**Addendum #1 - Issued on December 4, 2012**

Regarding Bids for **Renovations to Buildings B, C & D (ITB 12-033P)** for the Lucas County Commissioners, bid opening scheduled for December 17, 2012 at 2:00 P.M. (local time).

ADDENDUM NO. 001

**Renovations to Buildings B, C and D  
At the McCord Road Complex**

SHEET NO.  
**A0.11**

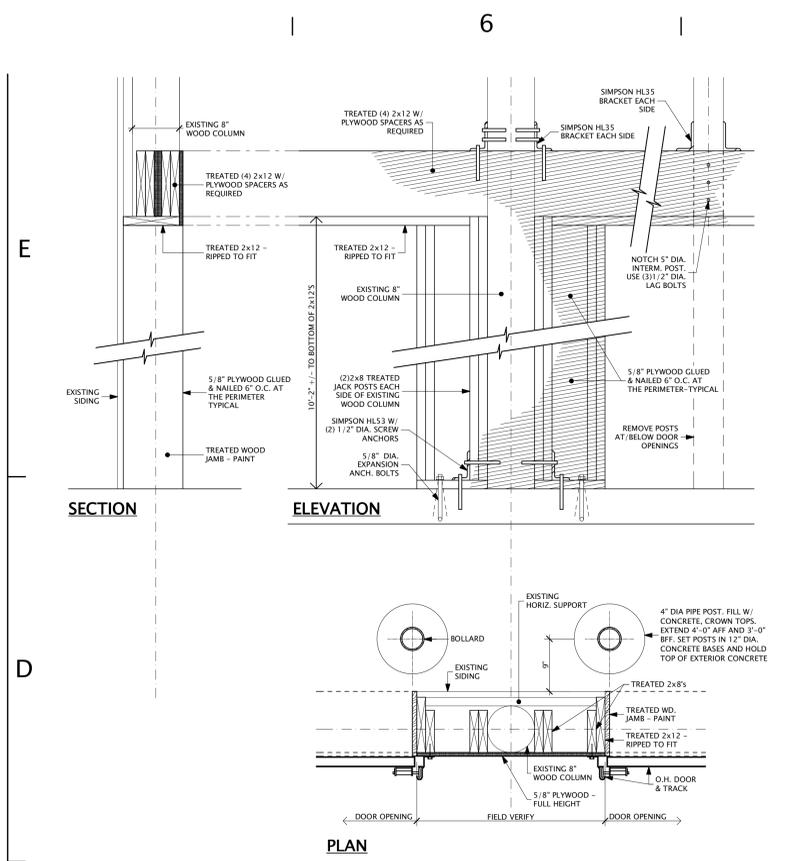
Item #1 Revise wall and added not to remove existing wall on north side of existing toilet room.

**FIRST FLOOR PLAN**  
 SCALE: 1/8" = 1'-0"

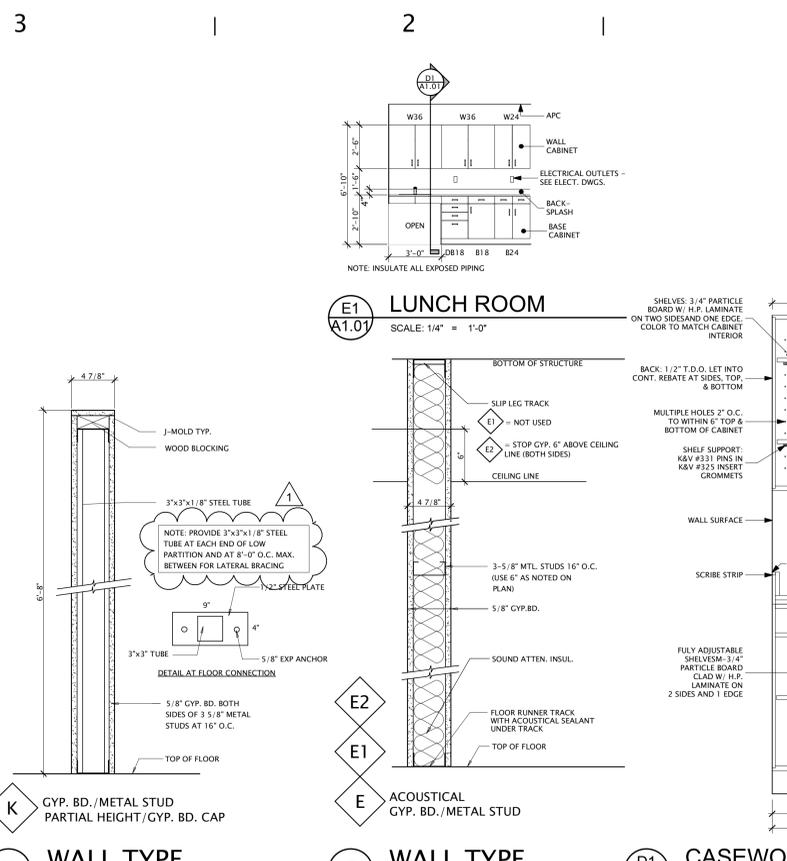
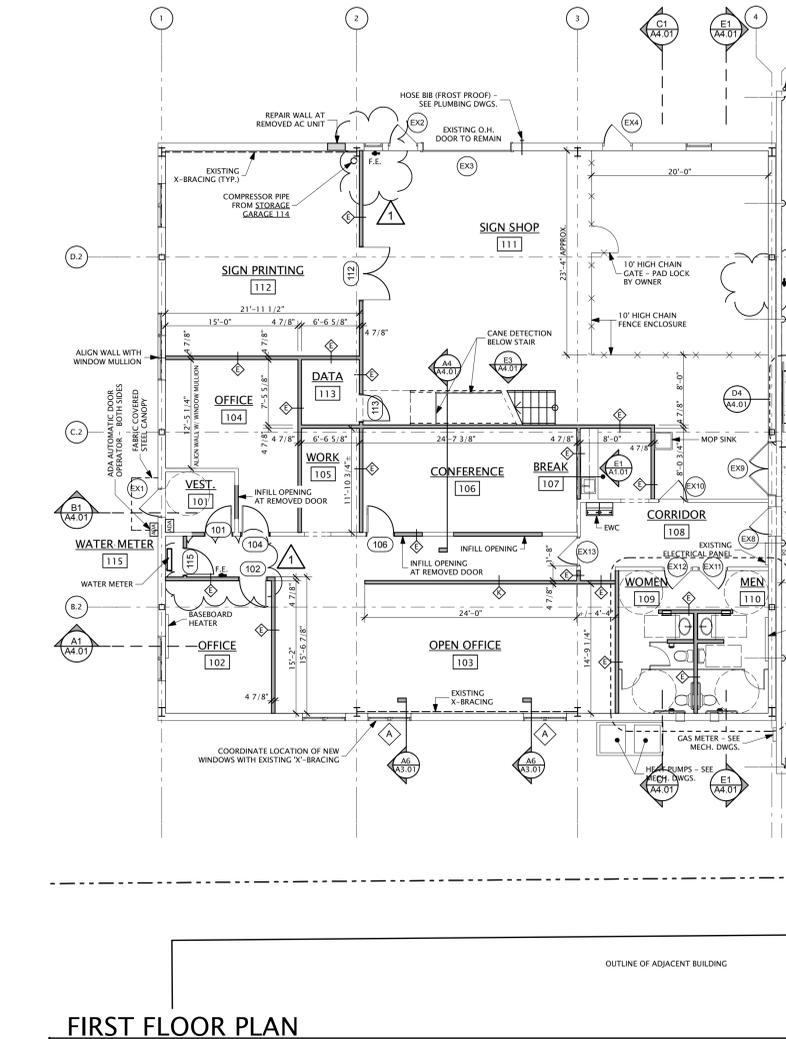
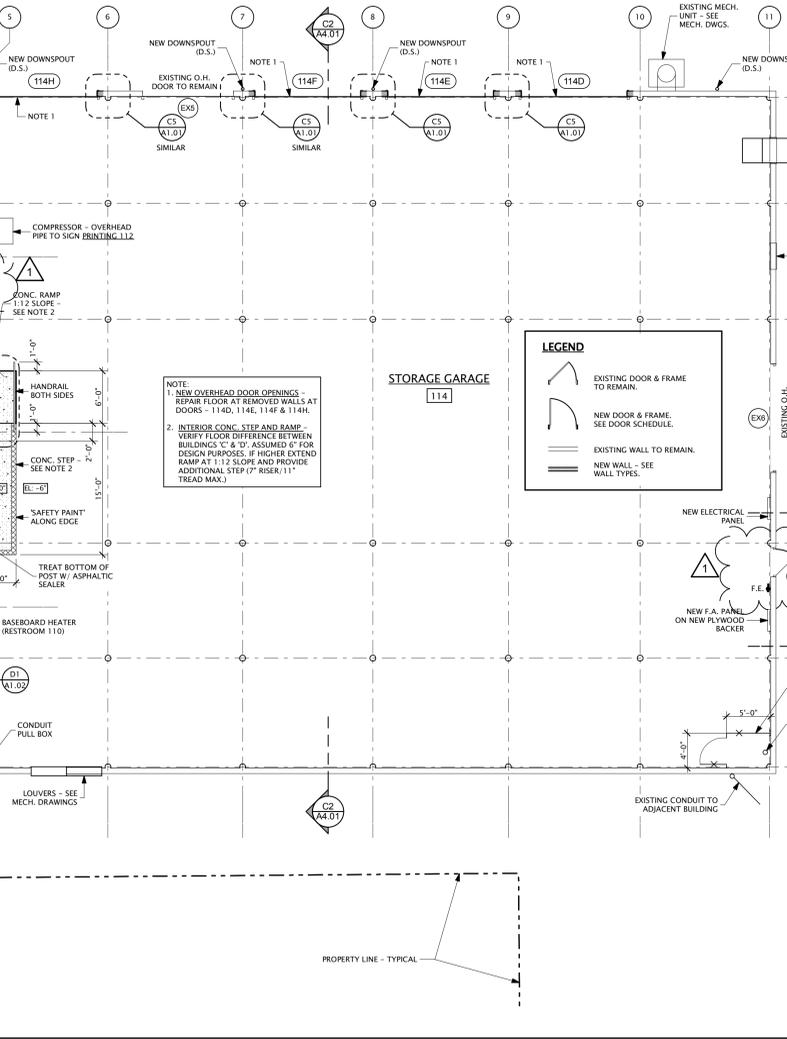
- Item #1 Added three (3) fire extinguisher locations to floor plan.
- Item #2 Revised spacing note for tube steel in Partition "K" detail.

SHEET NO.  
**A1.01**

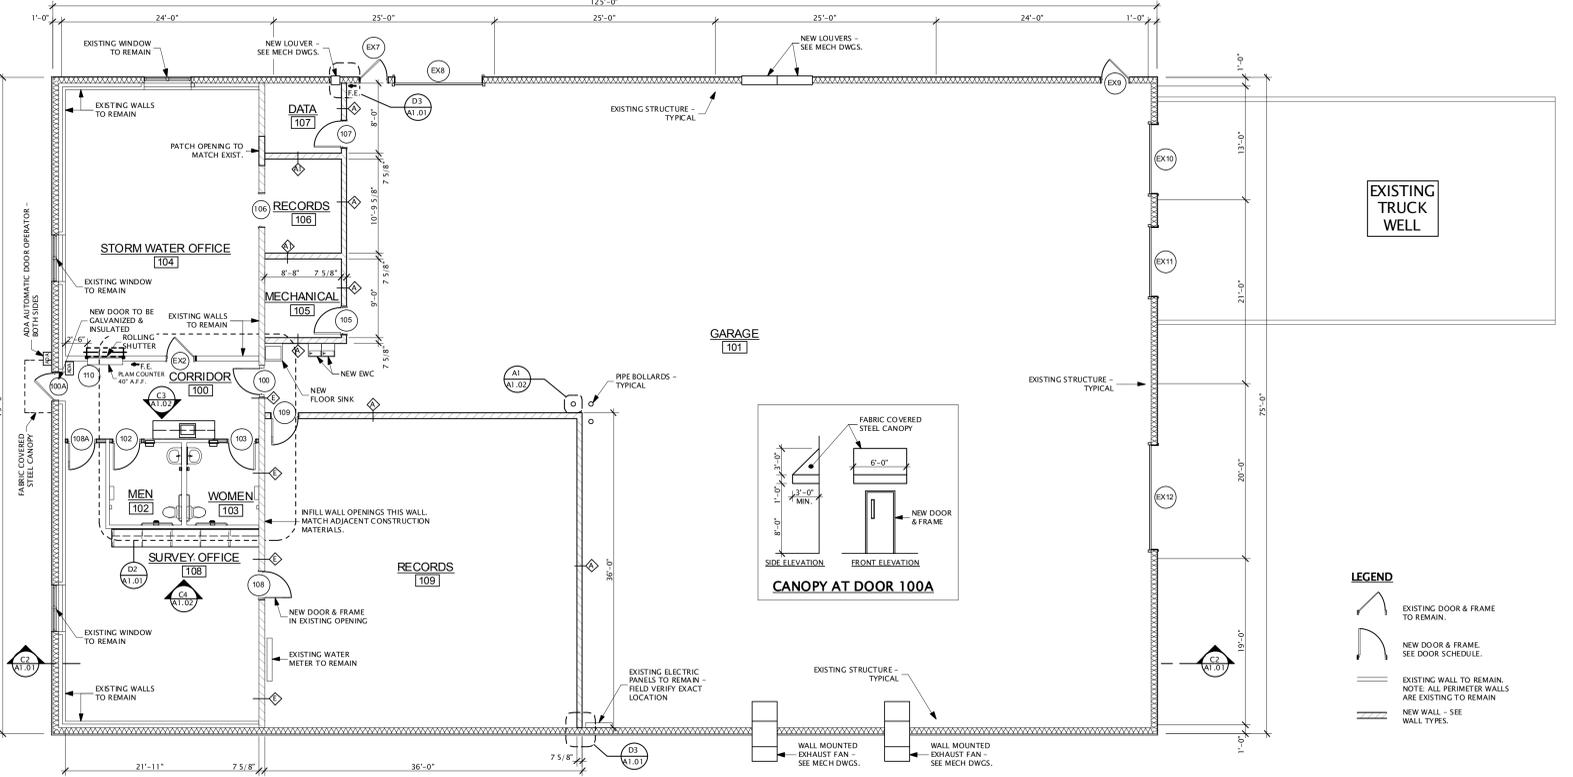
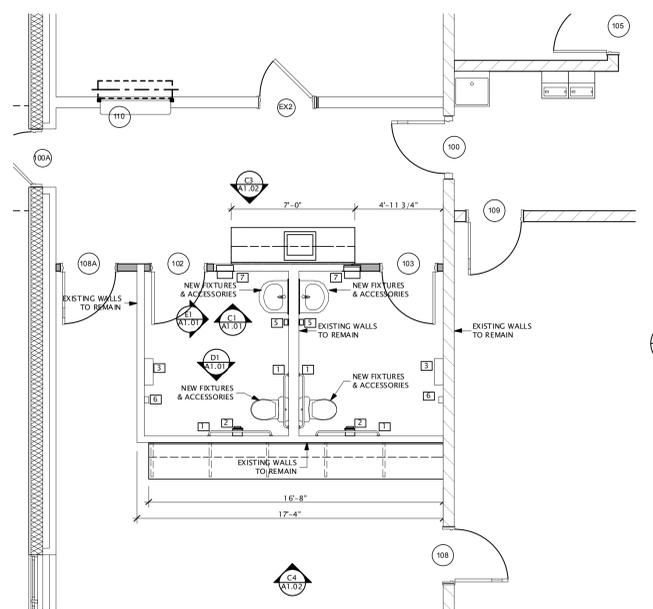
- Item #1 Added note to require new masonry in existing openings to be toothed into surrounding existing masonry construction.
- Item #2 Added note to remove existing Door 100 in preparation for new door and frame.
- Item #3 Added two (2) wall mounted fire extinguishers.

SHEET NO.  
**A1.02**

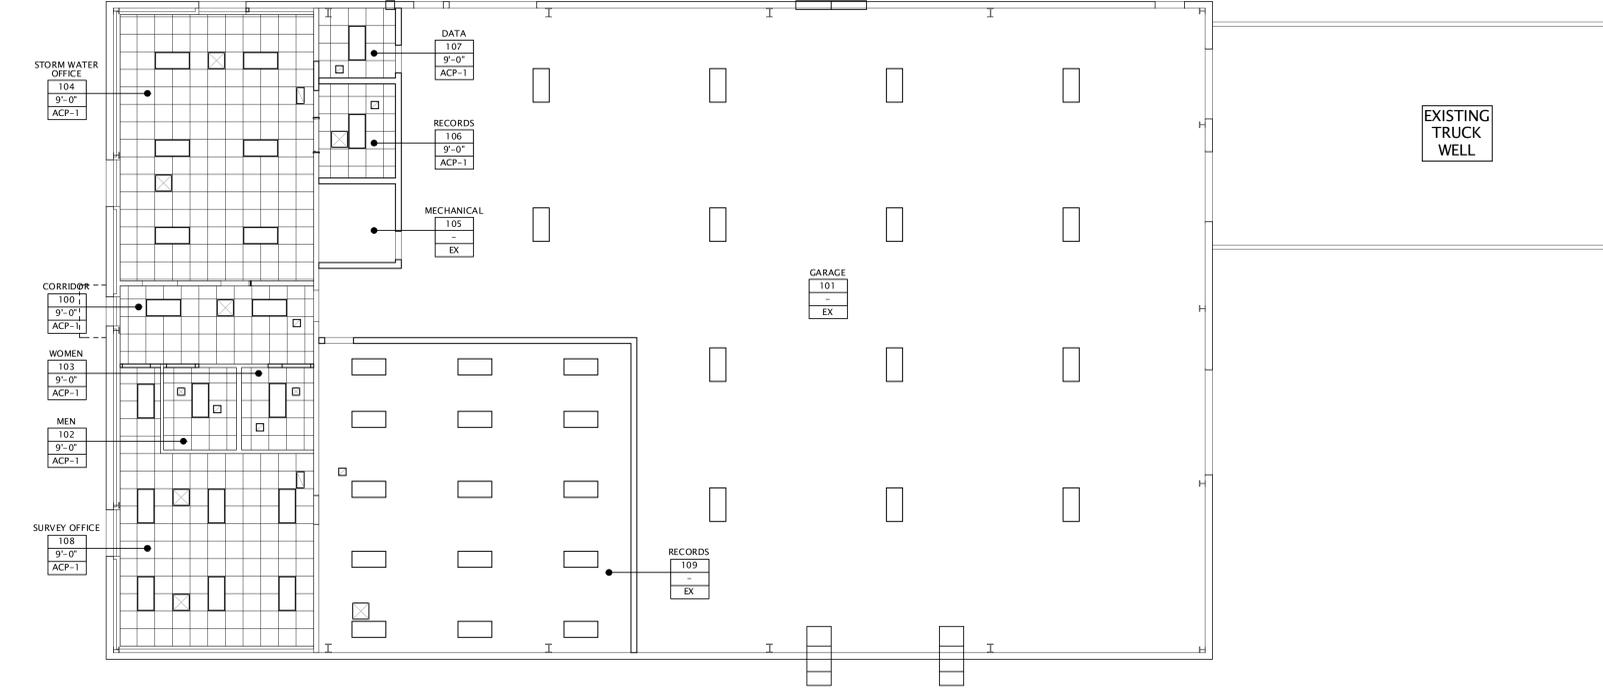
Item #1 Revised room finish call-out for Garage 101.

**D1 ENLARGED PLAN**  
A1.02 SCALE: 1/4" = 1'-0"

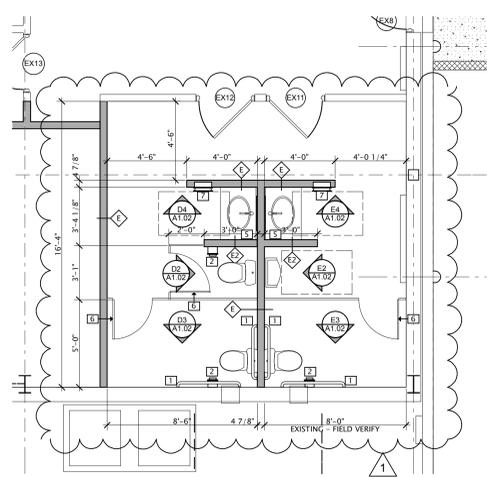
- Item #1 Added new wall between Women 109 and Men 110 toilet rooms.
- Item #2 Revised wall type tags for Enlarged Plan "D1".

**A7.01**

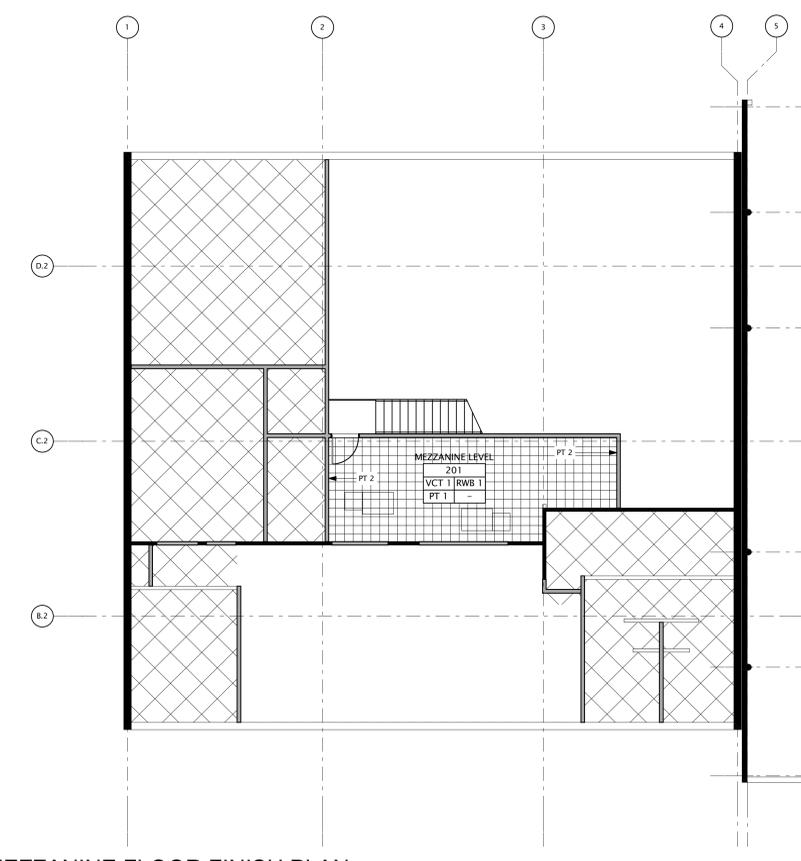
- Item #1 Added note within Building 'D' to provide finish on existing primary exposed framing system members.
- Item #2 Revised room finish materials for Building 'C'.
